Access Compliance Report

Public Rights-of-Way

(Curb Ramps)

Intersection ID: 11613	Main Street: W_7TH_ST	Cross Street: N_GRAHAM_ST	Location: W
ADA ID: D8EE908AA950	Ramp Type: BlendTrans1	Initial Pass/Fail: Fail	Overall Compliance: No
Severity Score: 12.5			
Codes/Mitigation Info/Possible Solution		Field Measurements/Component Compliance

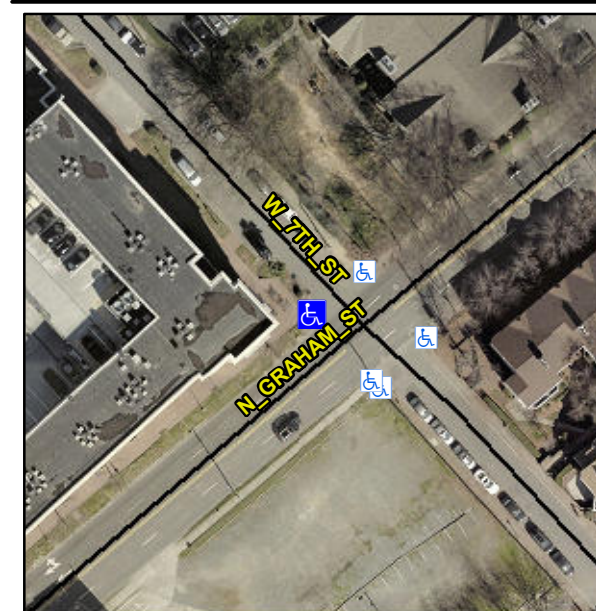
Possible Solutions:

Remove & Replace Curb Ramp With Two New Directional Ramps or Equivalent.

PROW/ADA:

R304.5.3
